**SUNDRY NOTICES AND REPORTS ON WELLS**  
*Do not use this form for proposals to drill or to re-enter an abandoned well. Use form 3160-3 (APD) for such proposals.*

Conoco proposes to plug and abandon this well using the attached procedure. Also attached is a current and proposed wellbore schematic.

# AXI Apache N #11

## BLM CONDITIONS OF APPROVAL

**Proposed P & A**

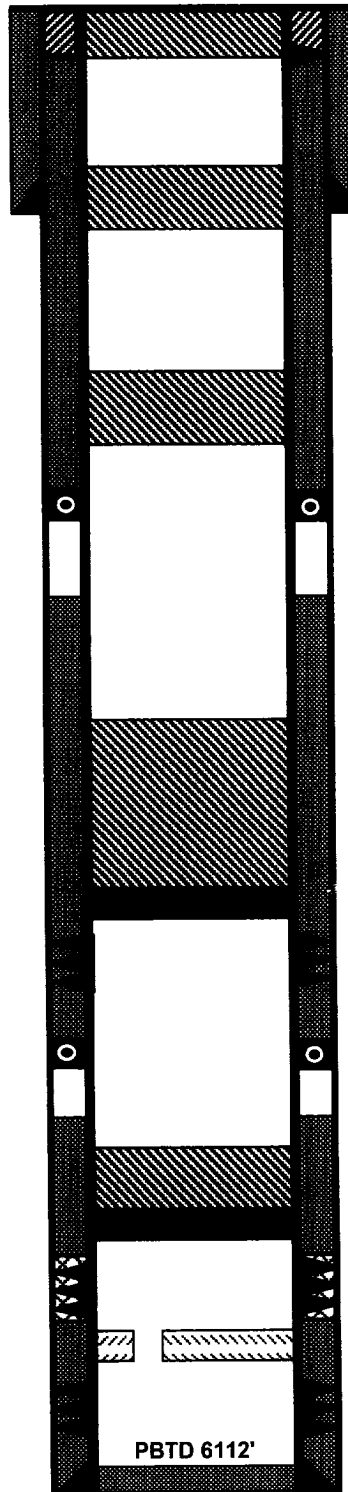
**Plug #5: 50'- Surface**  
Cmt with ~~20~~ sxs

7. **Plug #5 (Surface)**: Perforate 2 squeeze holes at 50'. Establish circulation out bradenhead with water. Mix approximately 20 sxs cement and pump down the 5-1/2" casing to circulate cement to surface. Shut well in and WOC.

Plug # 5, increase to 100' and 34 sacks.
